RE: Docket No. 466: Frost Bridge to Campville 115-kV Project
Development & Management Plan Change Notice Request:
Proposed Access Road Shift: Town of Thomaston

Frost Bridge to Campville 115-kV Project

Development & Management Plan

Thomaston, CT Map Sheet 21 of 35

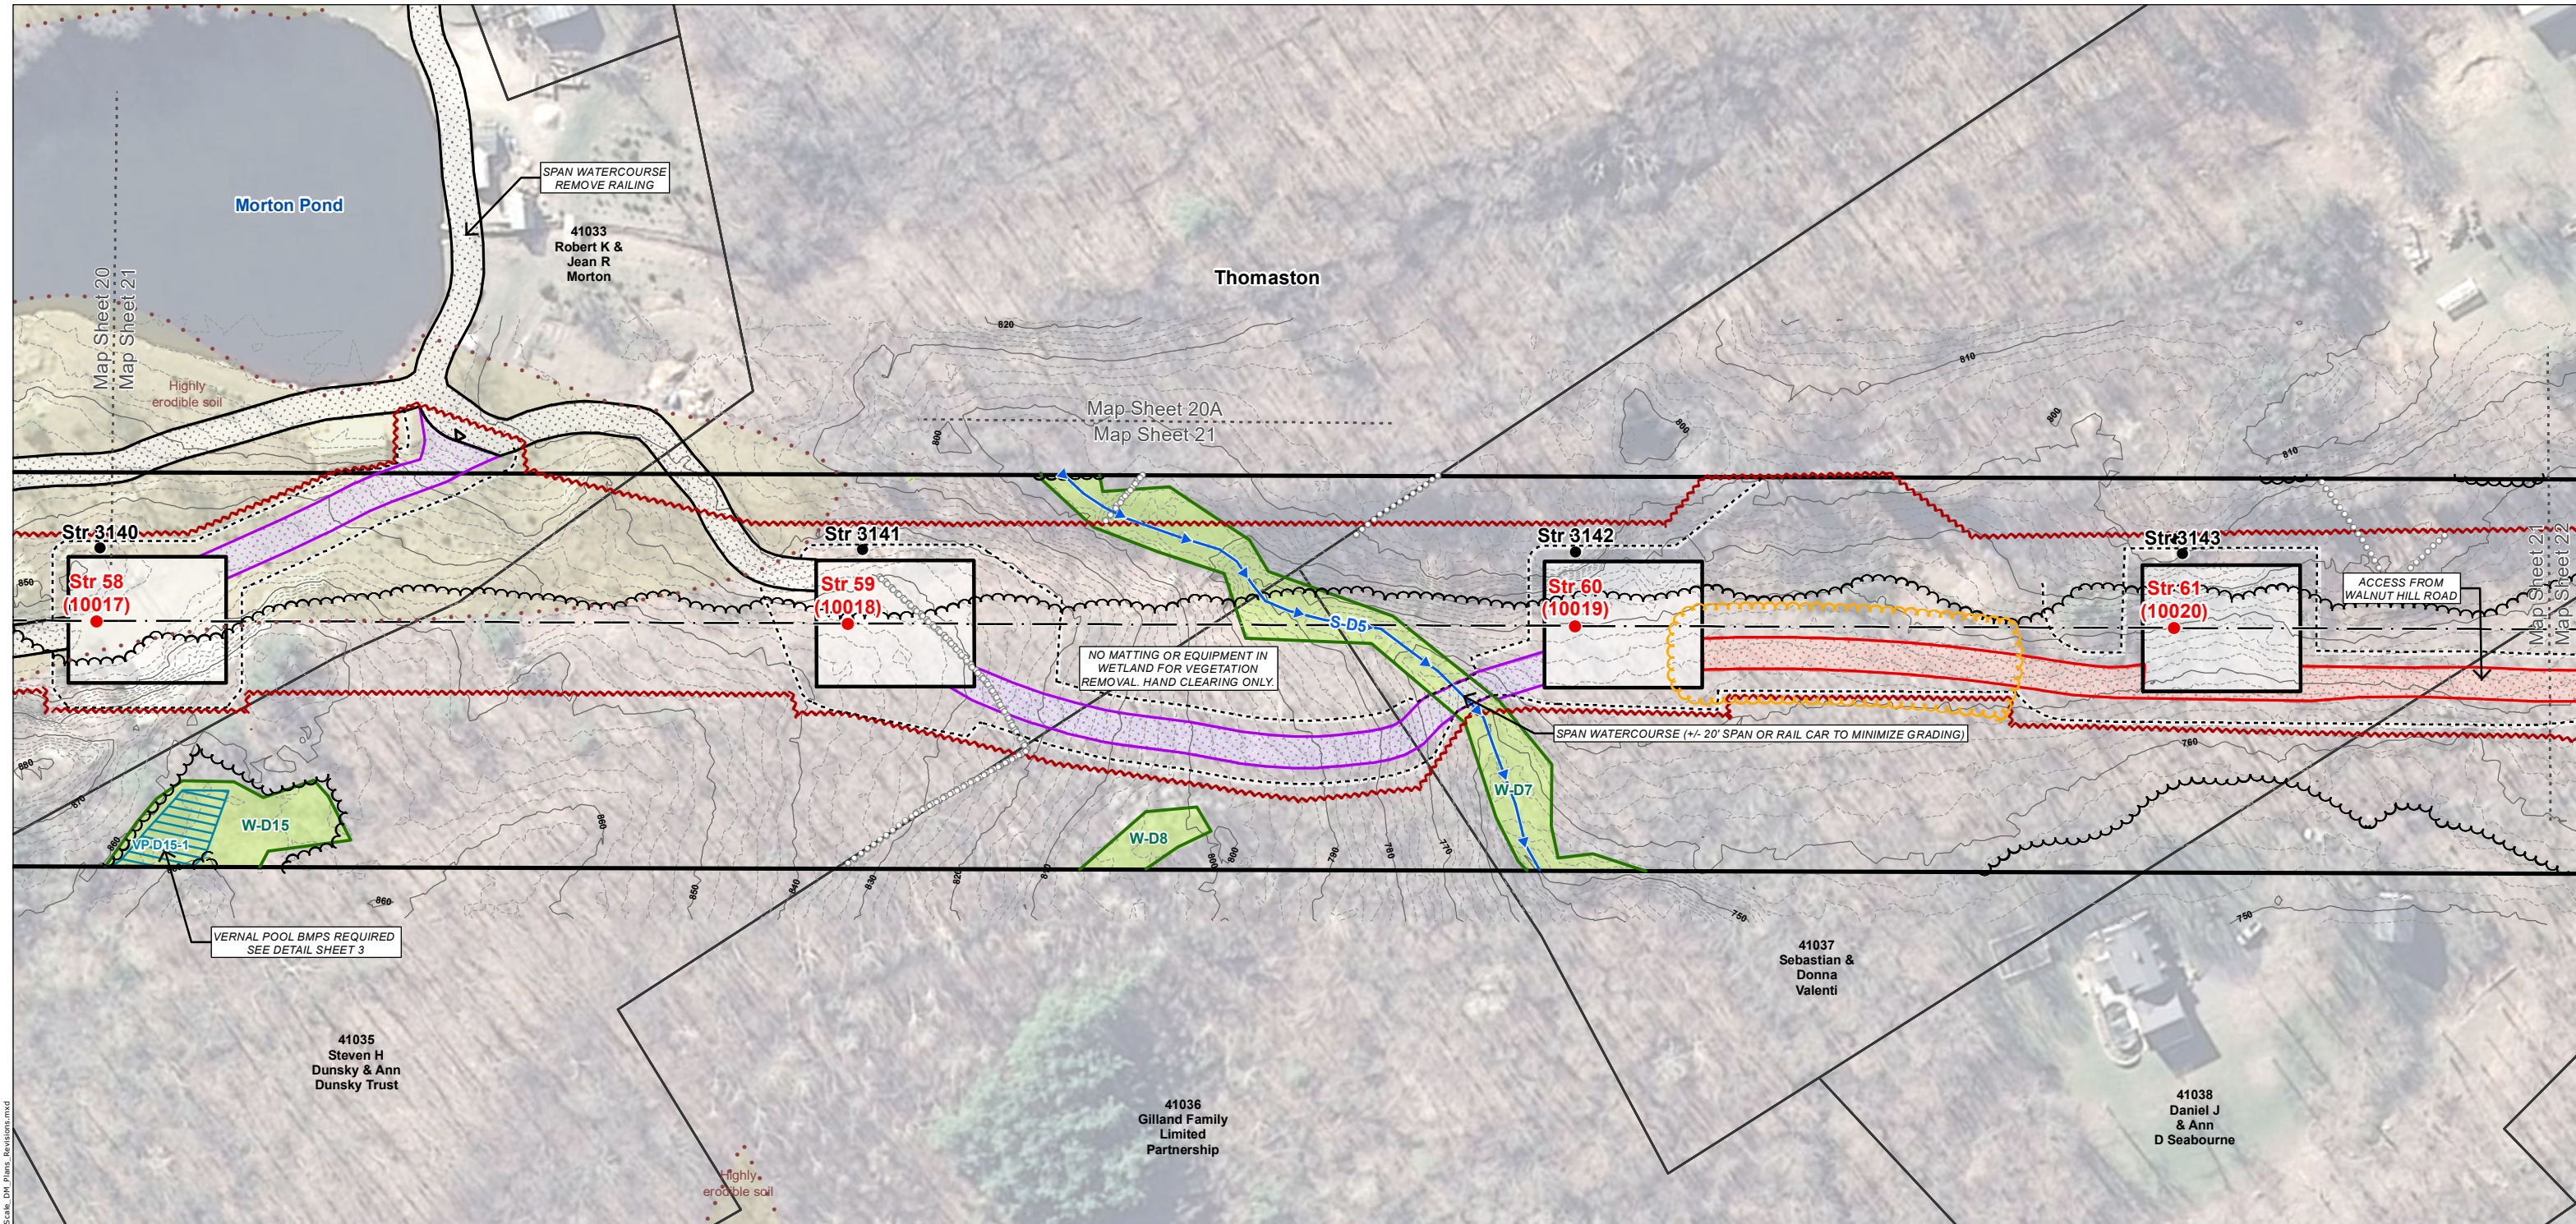
The proposed change involves a shift in the location of a portion of the access road between Structures 60 and 61 (Line List 41037, D&M Plan Mapsheet 21). As currently planned, the access between these two structures includes part of an existing access road that extends off the ROW (which would have to be improved) and portions of new access roads that would extend it to Structures 60 and 61. The connection of the off-ROW access into Structure 60 would traverse steep terrain.

To avoid this steep terrain, Eversource proposes to eliminate the use of the off-ROW portion of the existing access road and instead construct the access road between structures 60 and 61 entirely within an upland area within the ROW, as illustrated on the attached D&M Plan Mapsheet 21 (Revision 2). The proposed access road shift would decrease the length of the road between Structures 60 and 61 by approximately 100 feet and facilitate stormwater management during construction by avoiding steep terrain. The property owner (Line List 41037) has been notified of the proposed access road shift.

NO.	DATE	REVISIONS	BY	CHK	APP	APP
REV 2	4/6/2017	NEW ACCESS ROAD WITHIN ROW BETWEEN STRUCTURES 60 AND 61 TO AVOID STEEP GRADE		NC	MD	
REV 1	1/24/2017	ADDED EXISTING ACCESS FOR TEMPORARY CONSTRUCTION ACCESS TO STR 3171, ADDED PROPOSED CHAIN LINK FENCE, ADDED EXISTING ACCESS ROAD CALLOUT, AND REMOVED WETLAND WORK RESTRICTION NOTE		NC	MD
